**DOCKET NUMBER 50-483
CALLAWAY PLANT
UNION ELECTRIC COMPANY
RESPONSE TO REQUEST FOR ADDITIONAL INFORMATION
ON REVISION TO TECHNICAL SPECIFICATION 5.5.9
"STEAM GENERATOR (SG) TUBE SURVEILLANCE PROGRAM"**

**REQUEST FOR ADDITIONAL INFORMATION
REVIEW OF THE CALLAWAY PLANT APPLICATION
FOR REVISION TO TECHNICAL SPECIFICATION 3/4.4
TAC NUMBER: MB1214**

Figure R6-15. EDM Notch Cn30: Sleeve Inner Diameter, 0.012" design depth

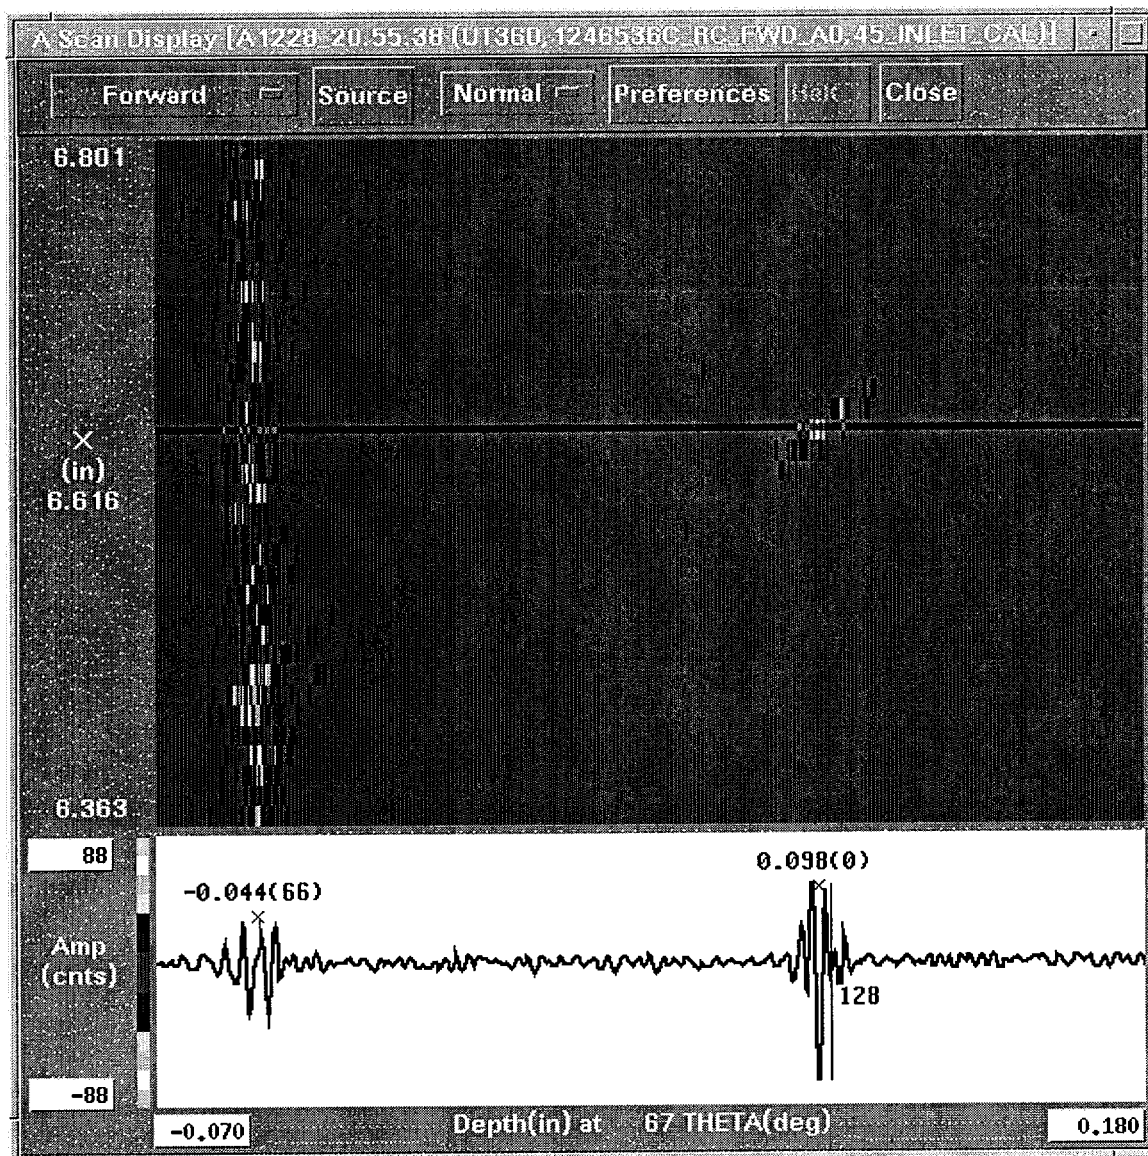
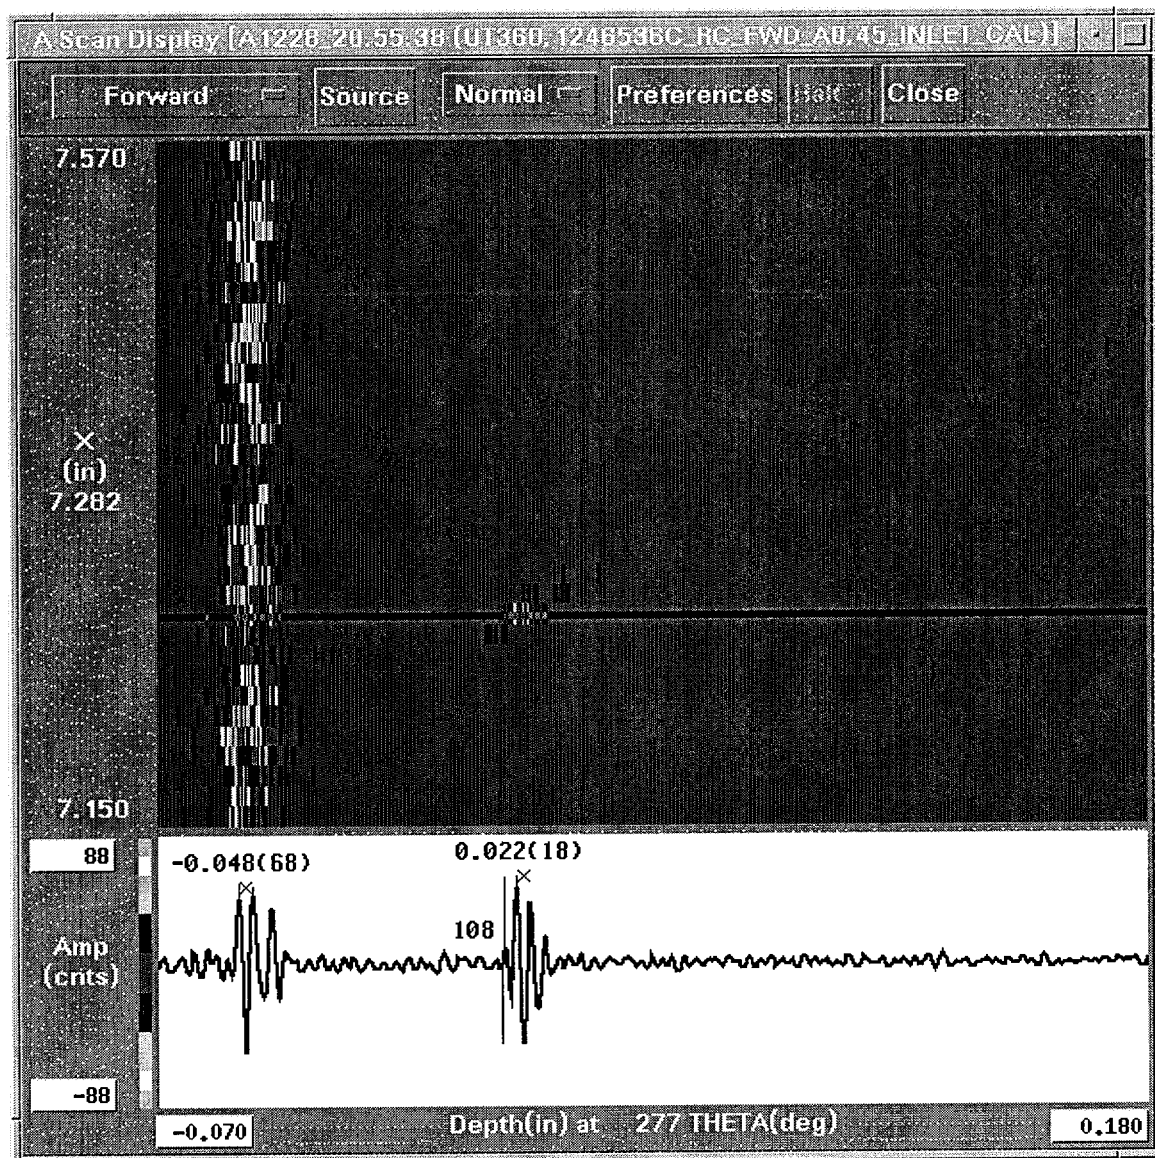
RAI # 6. During the meeting, FTI indicated that PWSCC detectability in the sleeve could be inferred from the ID notches in the UT calibration standards and the data sets containing pits. It is not clear to the staff how detecting EDM notches in the calibration standards or another degradation morphology such as pits would infer an ability to detect tight flaws such as PWSCC. Explain the basis for the statement that sleeve PWSCC ID defects will be detected, and the resulting sensitivity and POD, since the peer review (ETSS # 98404) only covers volumetric defects. Please provide additional discussion or, preferably, additional data to support the claims of the capability of the technique to detect PWSCC in the sleeve. (Question from the 6/7/01 meeting held with UE, FTI, and the NRC staff)

The assertion about the calibration standard and the inner diameter sleeve pit was to demonstrate sensitivity of the ultrasonic technique to inner diameter initiated flaws. The inner diameter pit provides a difficult cross-sectional target due to its cylindrical shape. This was felt to be a more challenging test of the detection capability of the shear wave transducers than the broad side of an EDM notch. The staff is correct in their opinion that neither of these flaws fully represent PWSCC, but these are the only morphologies available for evaluation since sleeve SCC cannot be fabricated.

To support the assertion that the system, (probe and technique) are sensitive to inner diameter flaws, three separate presentations will be offered. The first will show the sensitivity of the system to the inner diameter EDM notches in a calibration standard. The data was acquired in accordance with the

The flaws labeled "Ai" are parent tube inner diameter axial EDM notches. The flaws labeled "Ao" are parent tube outer diameter axial EDM notches. The flaws labeled with the first character "H" are EDM contoured bottom holes. Of interest is the detection of "Ai10", the 0.004 inch deep inner diameter notch.

This is the A-Scan plot showing the inner diameter corner reflection, (full skip) for the notch "Ai10". The notch is at the expected depth for the full skip, (two times the wall thickness) 0.086 inch. The peak to peak amplitude of this reflection is 65 counts out of a possible 256 counts or 25% full screen height.

This is the A-Scan plot showing the inner diameter corner reflection, (full skip) for the notch "Ai30". The peak to peak amplitude of this reflection is 108 counts or 42% full screen height.

This is the axial EDM notch that is used to establish the sensitivity and time-of-flight to depth calibration. The sensitivity must be set between 50% and 80% of the digitizer full scale. For an eight bit digitizer, the full scale is 256 counts (cnts). The amplitude of this reflection is 178 counts or (178/256), 70%.
